ACCESSIBILITY ASSESSMENT REPORT · SAMPLE, FOR ILLUSTRATION ONLY

Town of Clearwater

FACILITY

Clearwater Public Library
1204 Main Street, Clearwater AB T0M 0M0

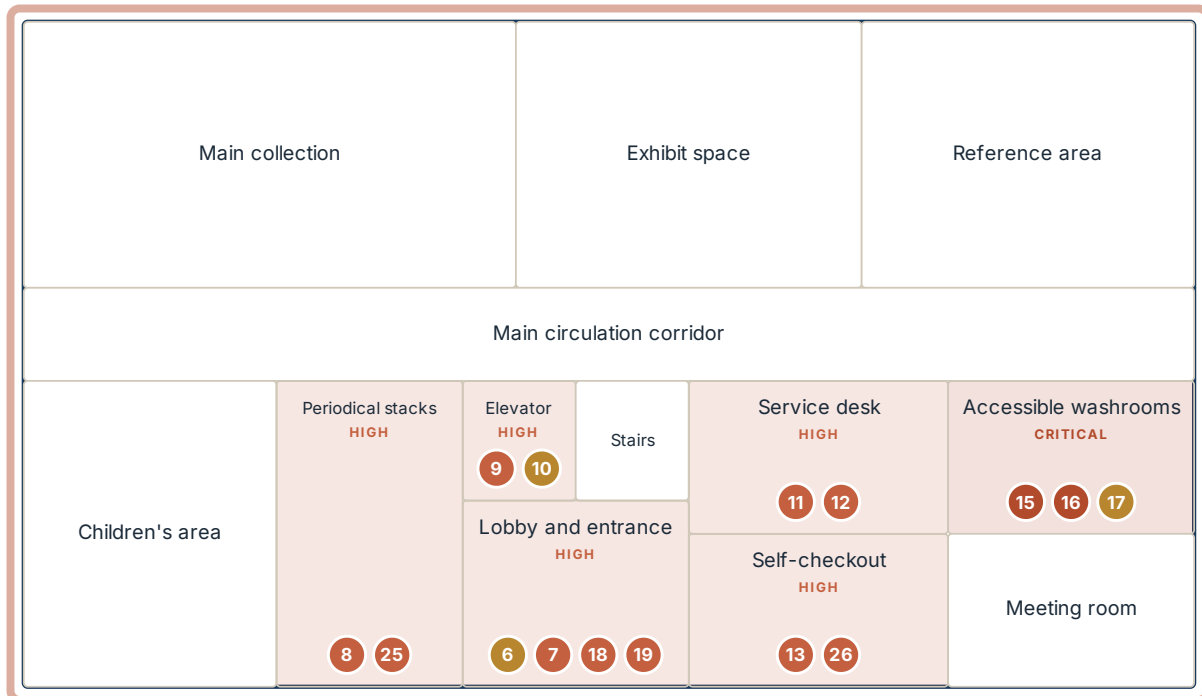
Finding 23 — no visual fire alarm coverage on the main floor. A whole-floor failure, so it carries no single pin. Costed once, with the upper floor, at \$8,500–\$14,000.
